Planning and Zoning Commission

May 6, 2020 – REGULAR MEETING

SUBJECT: **ITEM P20-035 & P20-036:** DEVELOPMENT PLAN AND HILLSIDE
CONDITIONAL USE PERMIT FOR A LAND DIVISION AT 808 UPPER REDMOND
ROAD IN THE NEIGHBORHOOD LOW DENSITY – 1 (NL-1) ZONE.

DEVELOPMENT PLAN AND HILLSIDE CONDITIONAL USE PERMIT
LOTS 1 & 2

DRAWING NO C3.0	JOB TITLE SNOW KING MOUNTAIN RESORT 2020 IMPROVEMENTS JACKSON, WYOMING		DRAWING TITLE NIGHT SKIING LIGHTING PLAN		DATE 3/31/2020		REV 4/28/2020	
	JOB NO 19-262-01				SURVEYED NE	ENGINEERED NE	DRAWN NB	CHECKED DD
							APPROVED DD

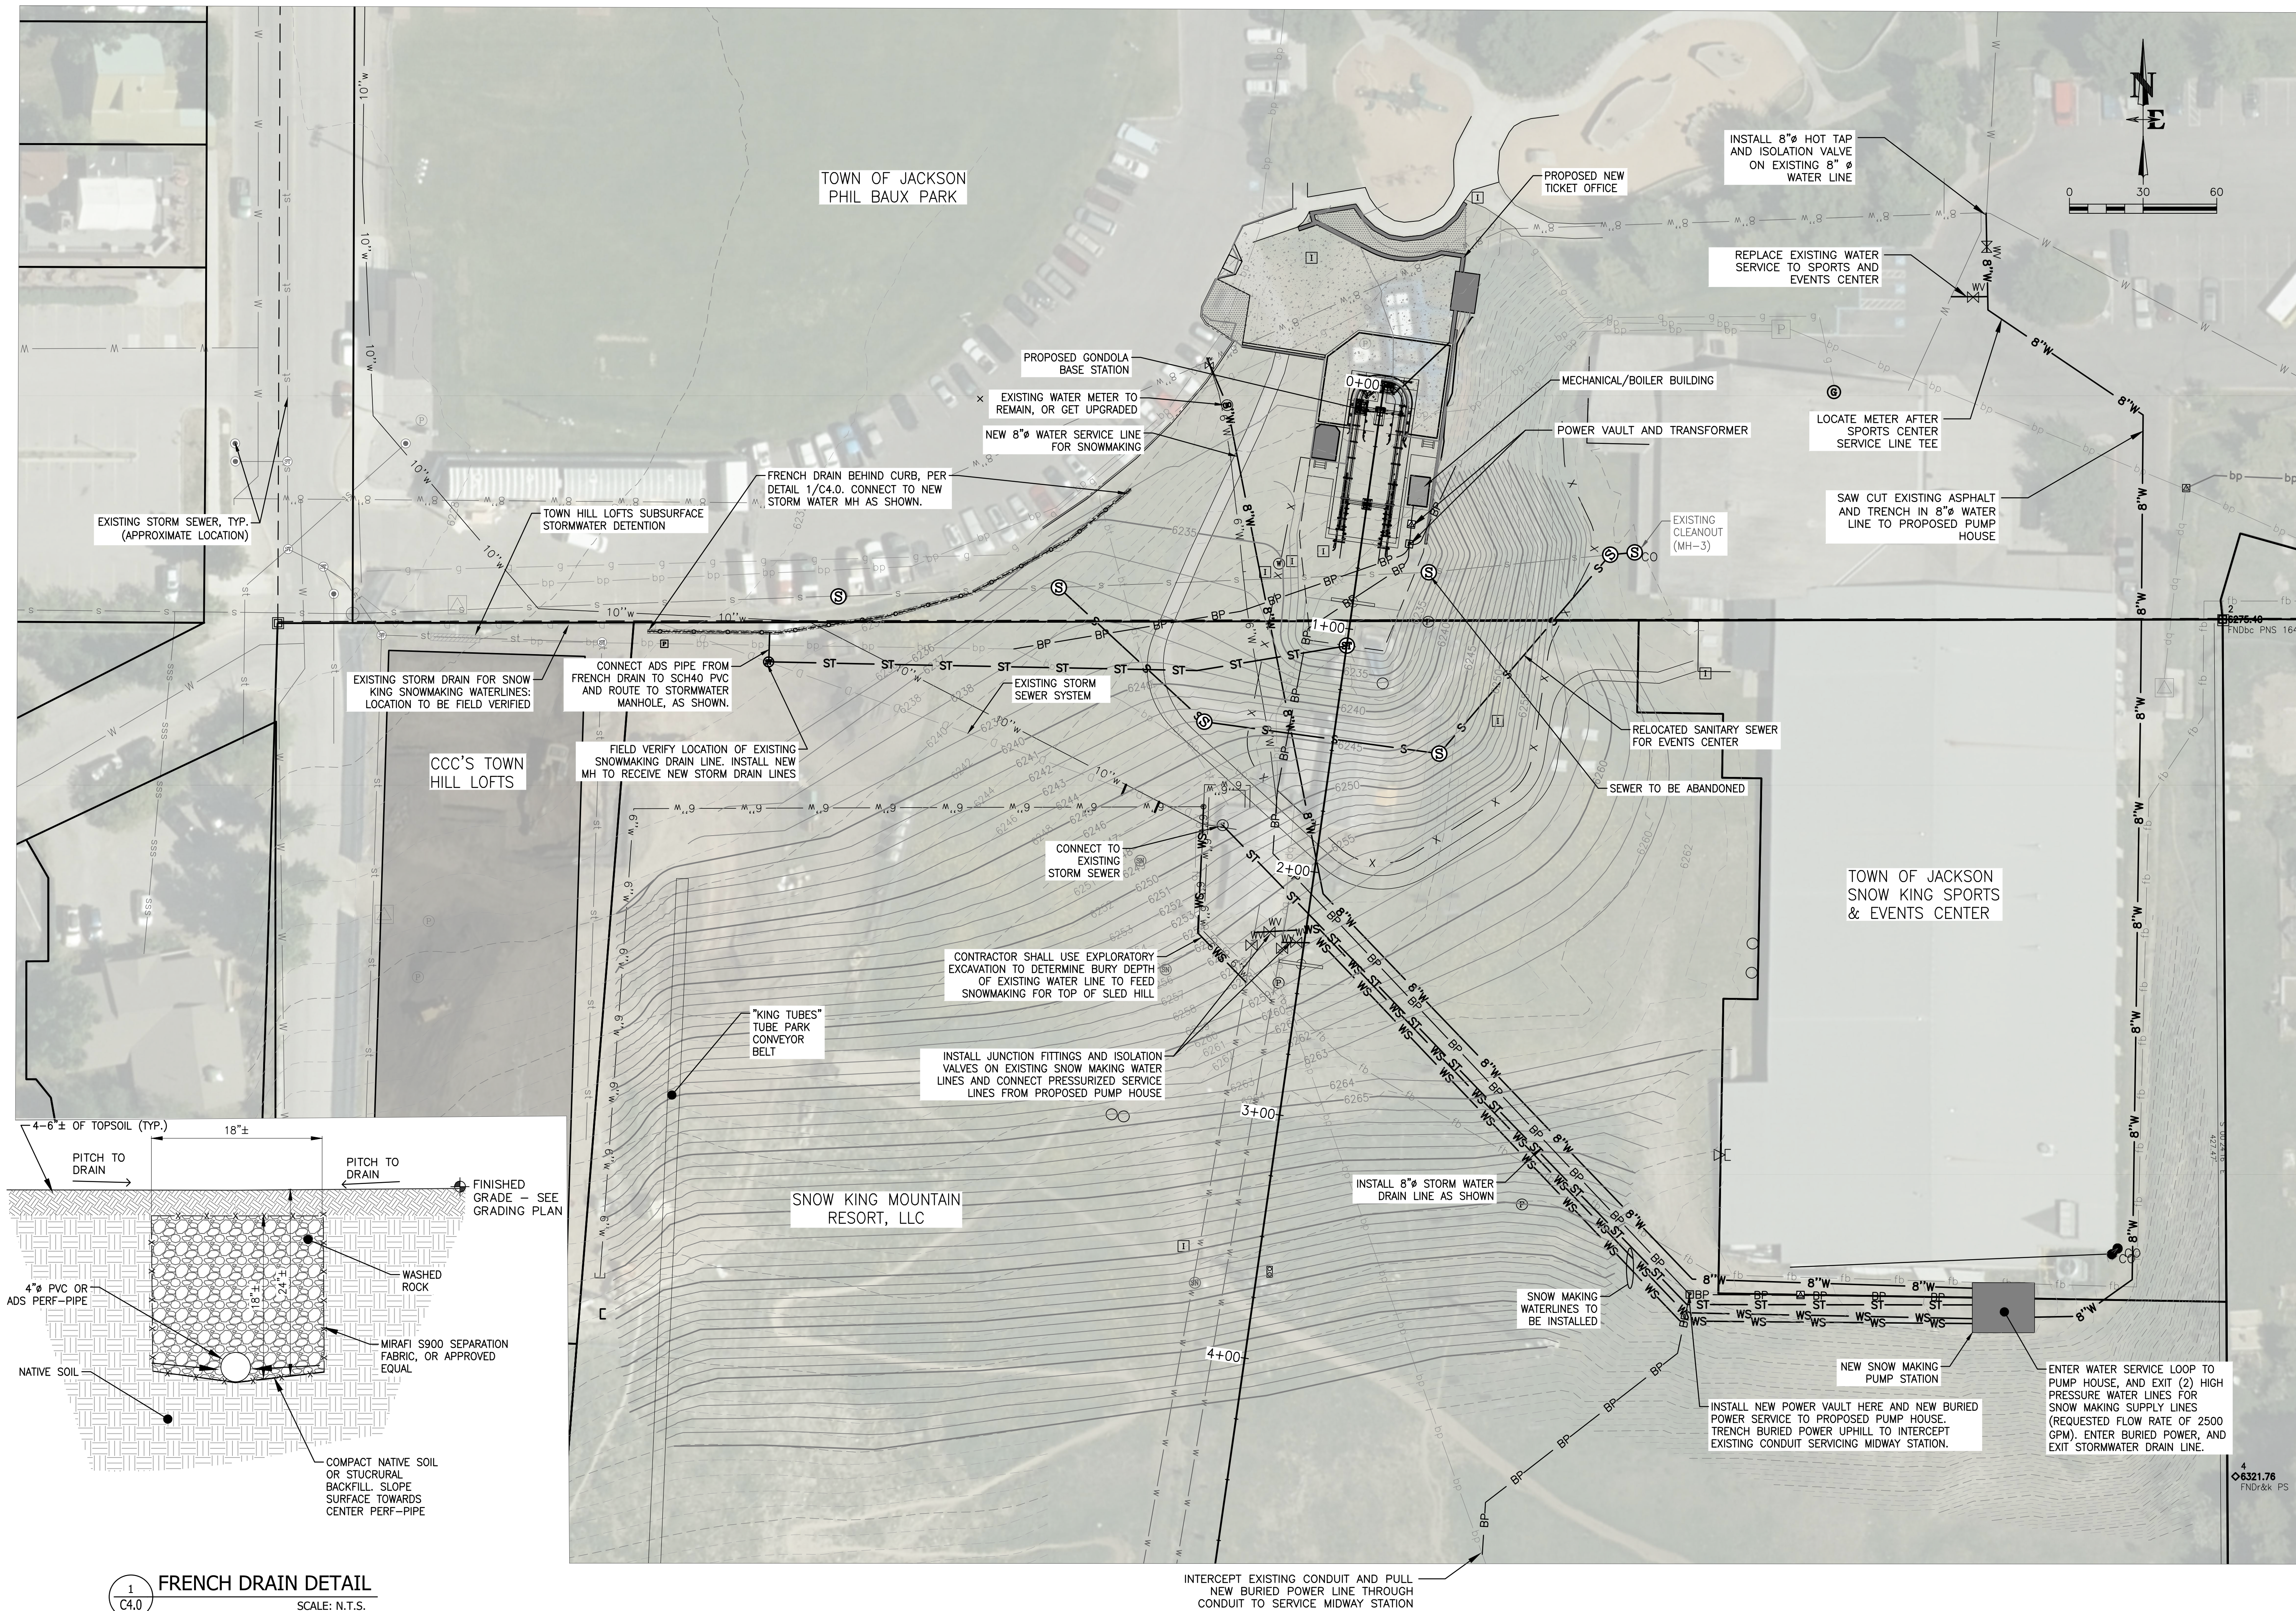
The applicant has submitted a Night Skiing Lighting Plan (sheet C3.0 of the applicant submittal) which indicates the location of proposed increased lighting for night skiing. In general, lighting is situated around the periphery and adjacent to stands of trees within the ski runs of 'Old Man Flats', 'Cougar', and 'Exhibition'. The lighting extends down the slope alongside the tube park and event center towards the proposed gondola base area in Phil Baux Park.
